## PROJECT NAME:Farber Building RenovationsPROJECT NUMBER:EN2401

#### ADDENDUM NUMBER: THREE

DATE OF ISSUANCE: January 15, 2025

**P-1.16**

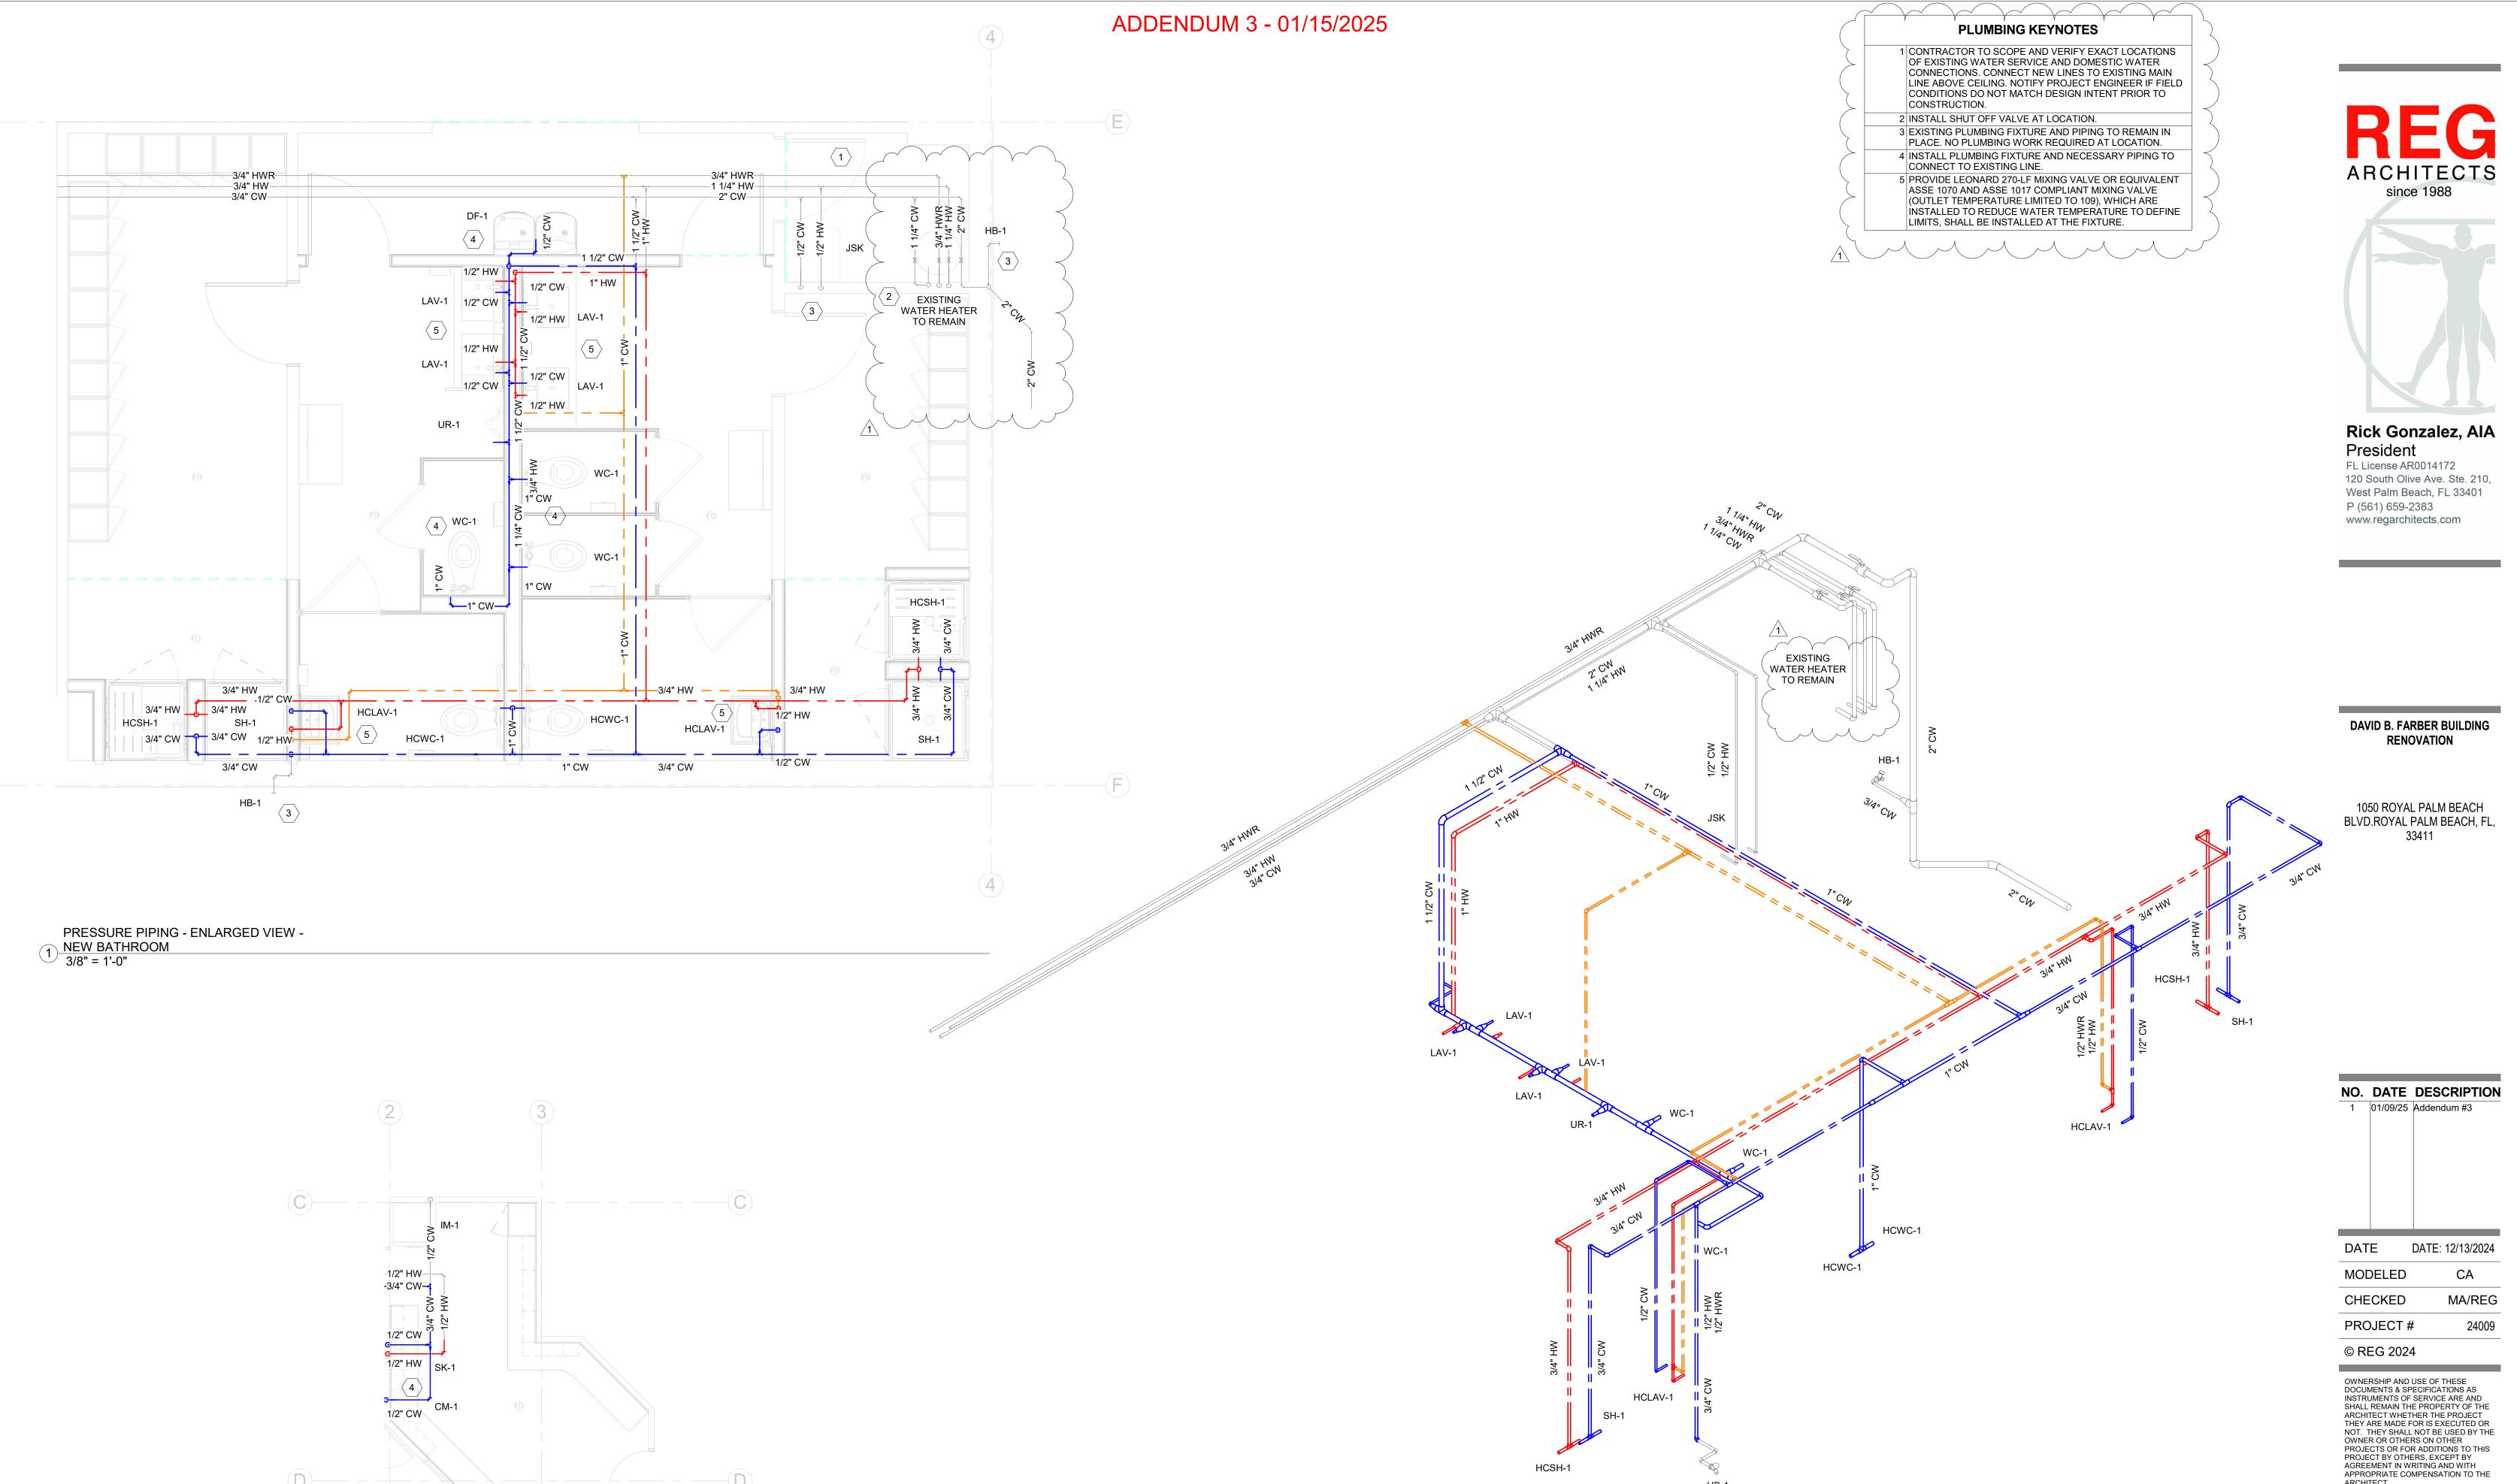
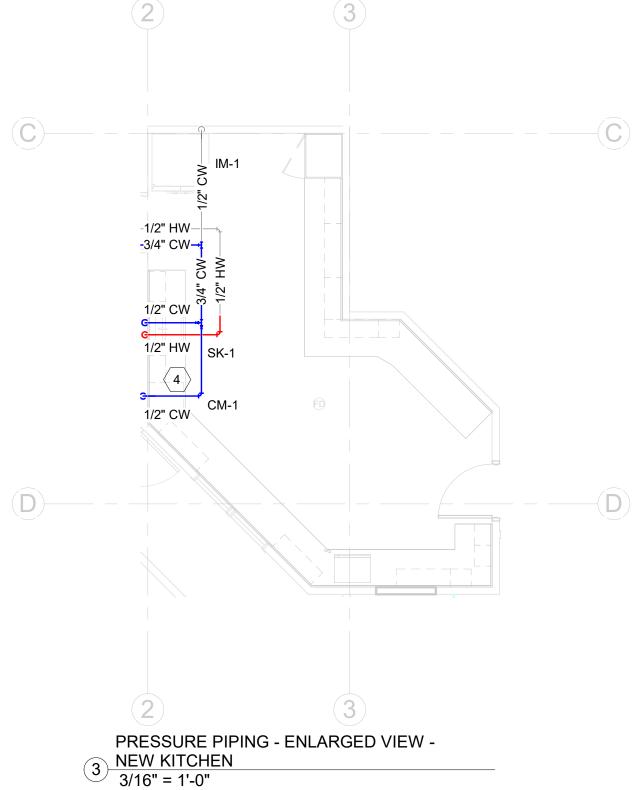
- 1) Bid opening date is changed from Tuesday, January 21, 2025 at 3:00 P.M. to Thursday, January 23, 2025 at 3:00 P.M.
- Bidders shall delete item 1 from Addendum two: The hot water heater noted on A-1.01, A-4.01, and P-1.16 call out shall be changed from remove and replace to existing shall remain
- Bidders shall remove plan sheets A-0.10, A-1.01, A-4.01, A-4.02, A-5.01, A-5.03, F-0.0, F-0.01, FA-1.01, P-1.12, P-1.13, P-1.15, P-1.16, P-2.01 and add revised Addendum three sheets A-0.10, A-1.01, A-4.01, A-4.02, A-5.01, A-5.03, F-0.0, F-0.01, FA-1.01, P-1.12, P-1.13, P-1.15, P-1.16, P-2.01 (attached)
